## ASSESSMENT REPORT

### ULAN COAL MINE Section 75W Modification MP 08\_0184 MOD 2

**Figure 3: Proposed Modification to the Ulan West LW 1-5**

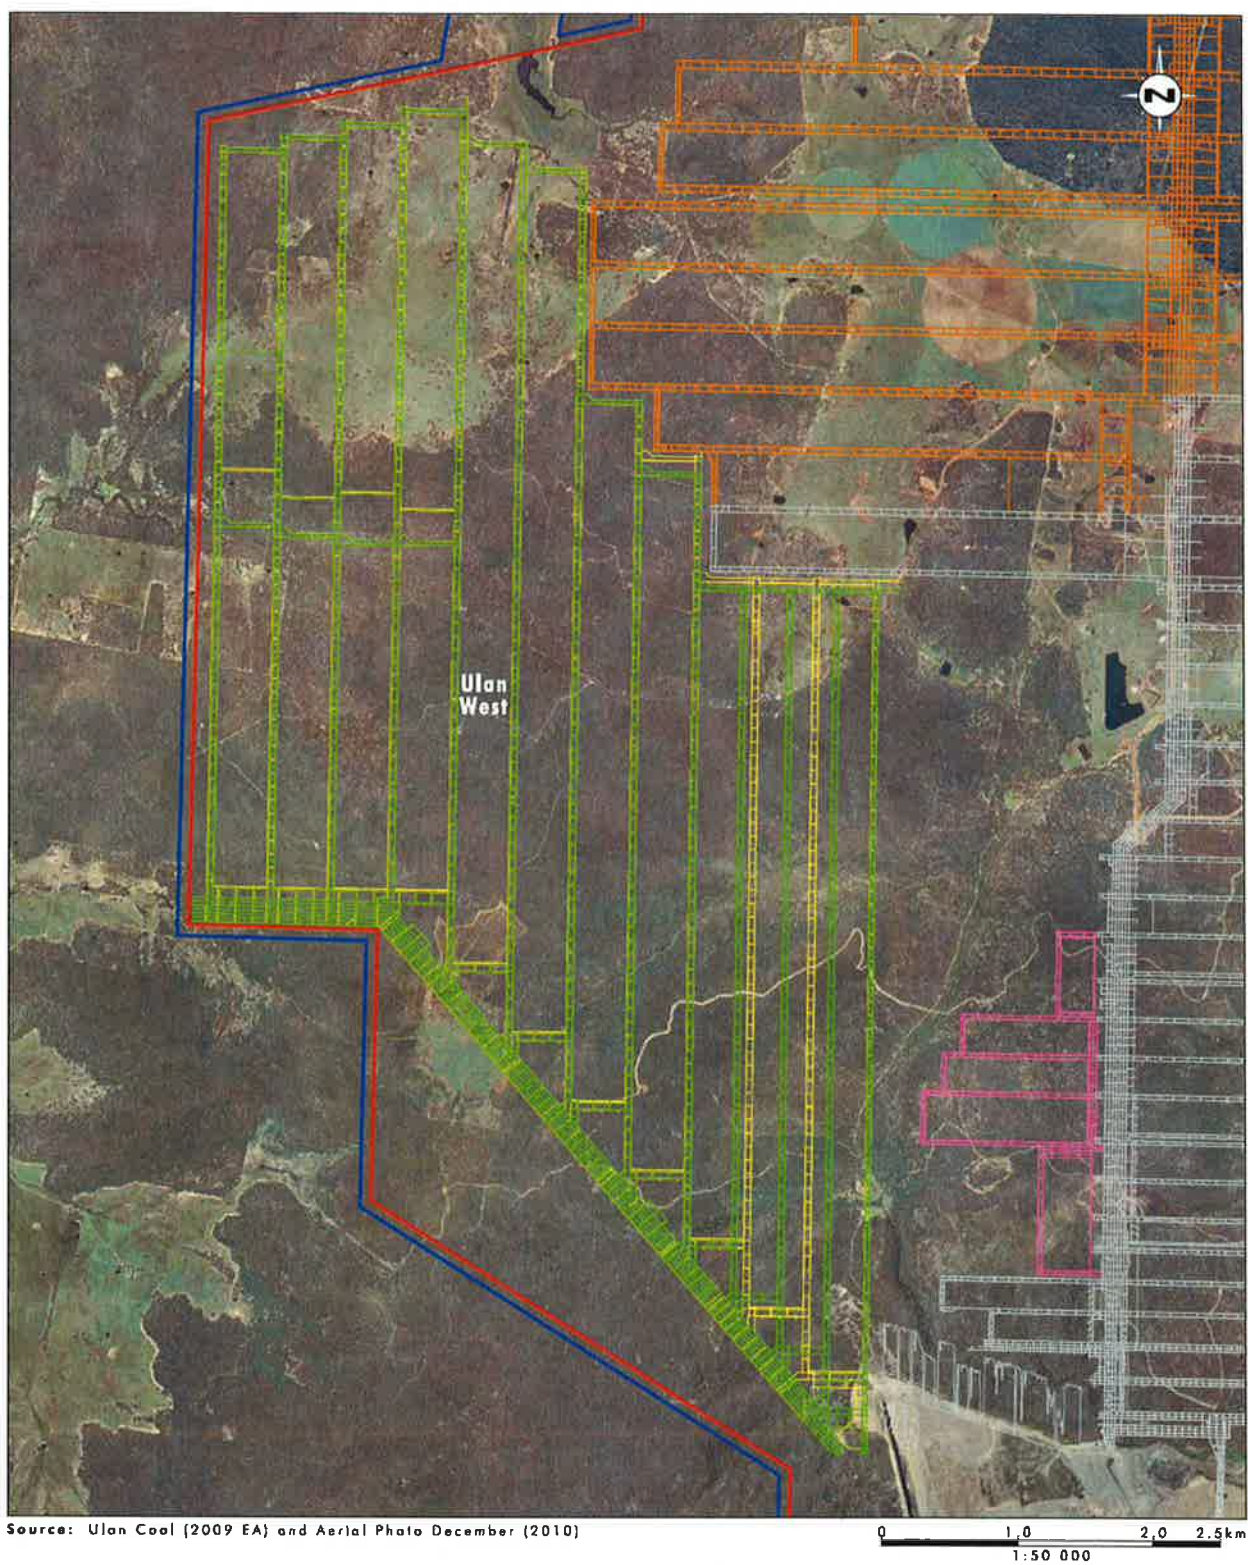
UCML is seeking approval to modify the panel geometry of the first 5 longwall panels (i.e. LW 1-5) within the Ulan West underground mining domain (see **Figure 3**). Specifically, the modification involves:

- increasing the number of longwall panels within the approved Ulan West Longwall 1-3 from three to four by reducing the panel width from the approved 400 metres to 250 metres (LW1) and 300 -305 metres (LW 2-4); and
- reducing the length of longwalls 1-5 by moving the northern end of the panels to the south.

This modified mine plan would reduce geotechnical issues associated with extracting longwalls in a ‘virgin’ area where there has been no stress relief either side of the first longwall. The remaining longwalls are proposed to be adjusted to fit within the approved Ulan West mining area. The length of the original Longwalls 1-4 has also been reduced to increase the size of the barrier between the old workings of Ulan No. 3 underground mine to the north.

The proposed modification to the Ulan West Longwall Panels 1-5 mine plan has the potential to cause changes to the approved subsidence impacts, which could affect a range of built and natural features.

SCT indicates that the proposed mine plan amendments will result in minor localised changes to subsidence predictions made as part of the Ulan continued Operations EA. However, these changes are not predicted to significantly change the subsidence impacts originally assessed and approved.

The Department is satisfied that the subsidence impacts associated with the proposed modifications to the Ulan West mine plan would meet all existing subsidence performance measures and would not cause any additional impacts beyond those already approved.
